ITEM 921, 921A, 921B, 923 & 925 Punchbowl Road & 21
Canterbury Road, Punchbowl

FILE DA-1075/2019

SUMMARY REPORT

DA-1075/2019 ASSESSMENT REPORT

Figure 3: Access arrangements showing the boundary between No 921 and No 923 Punchbowl Road

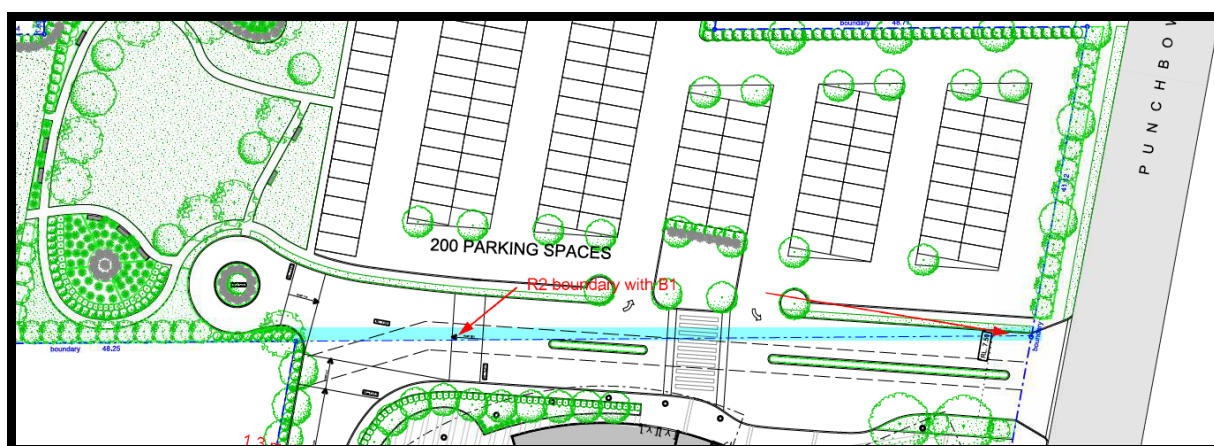
The proposal seeks to formally access and egress the site by 'straddling' the boundary between No 921 and No 923 Punchbowl Road. This boundary also provides for the change in zoning between B1 Neighbourhood Centre and R2 Low Density Residential. That is, No 923 Punchbowl Road (the southern lot) is zoned B1 while No 921 Punchbowl Road (the northern lot) is zoned R2 as shown in Figures 3 and 4 below.

A 'Registered Club' and 'Commercial premises' are prohibited within the R2 zone. The development has been designed and relies upon a portion of the R2 zoned land to provide vehicular access to the 'Registered Club' and the 'Commercial premises' and to provide the car parking required to enable these commercial operations.

Figure 7: Extract of the Height of Buildings Map

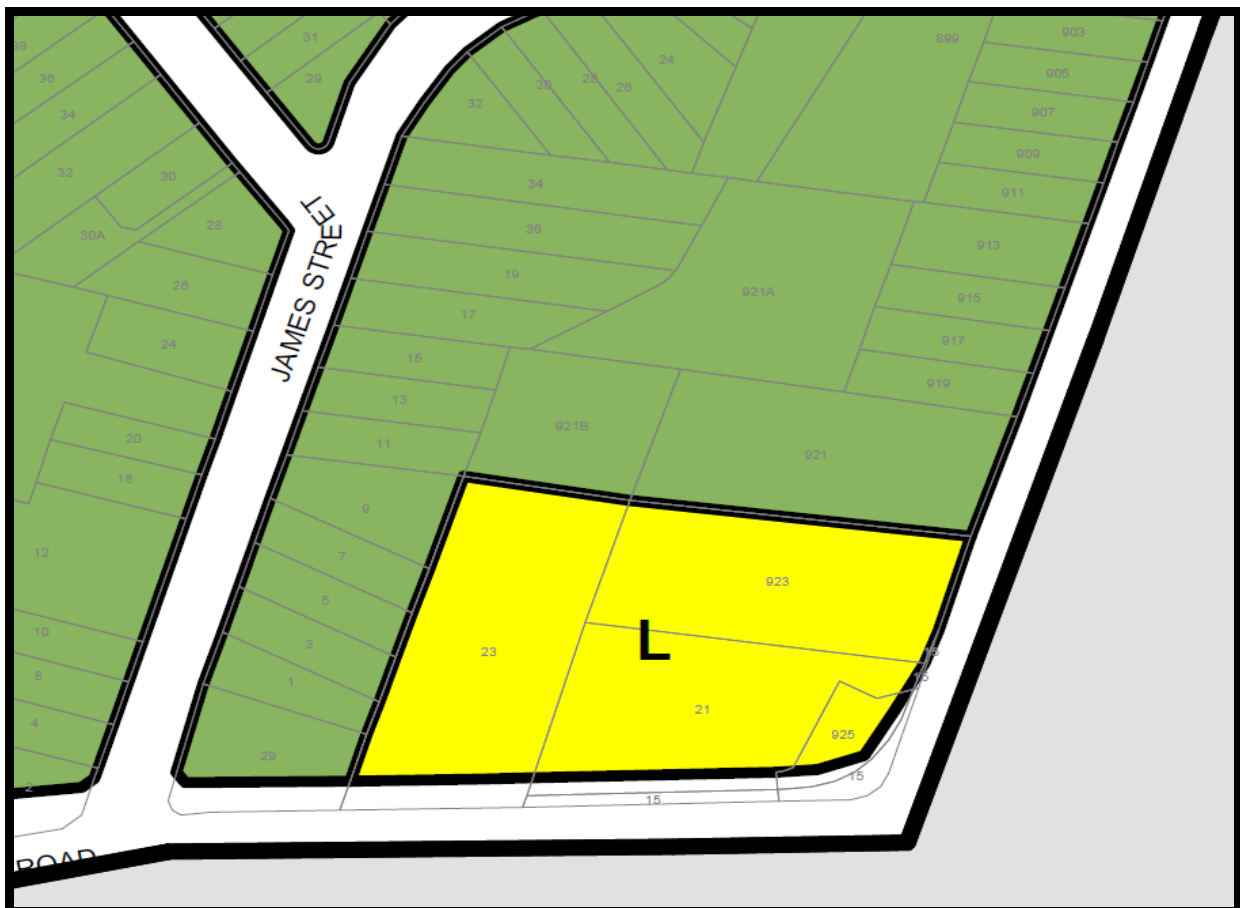
According to the Height of Buildings Map, buildings occupying Nos 923 and 925 Punchbowl Road and 21 Canterbury Road (which are those properties which are zoned B1 Neighbourhood Centre) are allowed a maximum building height of 11 metres while the remaining parcels of land, namely 921, 921A and 921B Punchbowl Road (which are those properties zoned R2 Low Density Residential) are allowed a maximum building height of 9 metres. The portion of the development site zoned SP2 Infrastructure does not contain a maximum building height.

The proposed 'built form' is contained entirely within the B1 Neighbourhood Centre zoned portion of the site. The built form provides for a maximum building height of 12.7 metres, exceeding the maximum height of 11 metres as specified within Clause 4.3 of BLEP 2015.

As per Clause 4.6(4)(a)(i), the applicant's Clause 4.6 has not established that compliance with the development standard is unreasonable or unnecessary in the circumstance of the case as per Clause 4.6(3). As per Clause 4.6(4)(a)(ii), the proposed development will not be in the public interest, having consideration of the objectives of the B1 Neighbourhood Centre zone and the objectives of the development standard.

Figure 8: Extract of the Floor Space Ratio Map

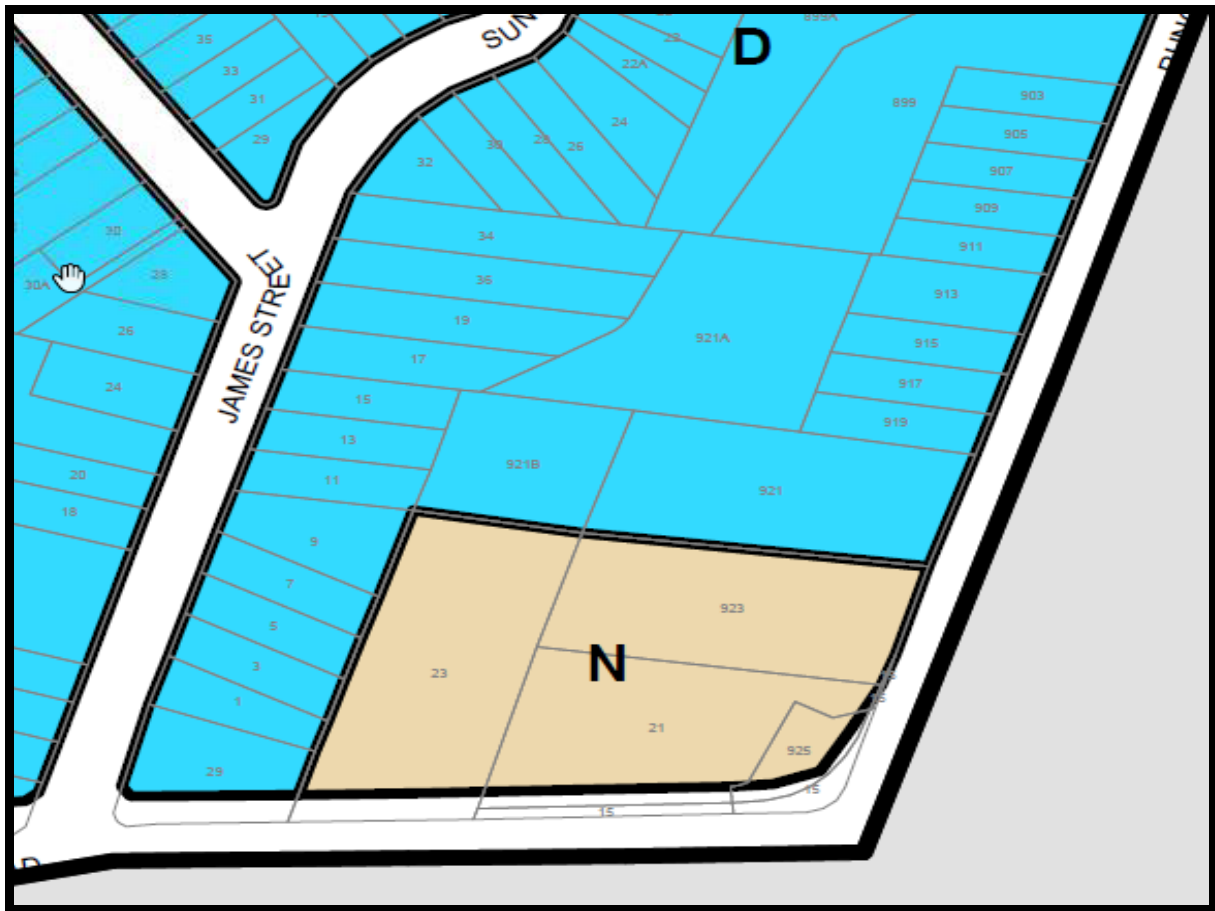
According to the Floor Space Ratio Map, developments occupying Nos 923 and 925 Punchbowl Road and 21 Canterbury Road (which are those properties which are zoned B1 Neighbourhood Centre) are allowed a maximum FSR of 1:1 while the remaining parcels of land, namely 921, 921A and 921B Punchbowl Road (which are those properties zoned R2 Low Density Residential) are allowed a maximum FSR of 0.5:1. The portion of the development site zoned SP2 Infrastructure does not contain a maximum floor space ratio.

As indicated earlier, the proposed built form is confined to that portion of the site which is zoned B1 Neighbourhood Centre. That is, there is no built form proposed on the portion of the development site that is zoned either R2 Low Density Residential or SP2 Infrastructure.

As the table above indicates, the applicant is permitted a maximum gross floor area of 7,598.74m². The total gross floor area of the development equates to 13,656m². The application is therefore seeking consent for an FSR of 1.797:1 being an 80% departure to the development standard.
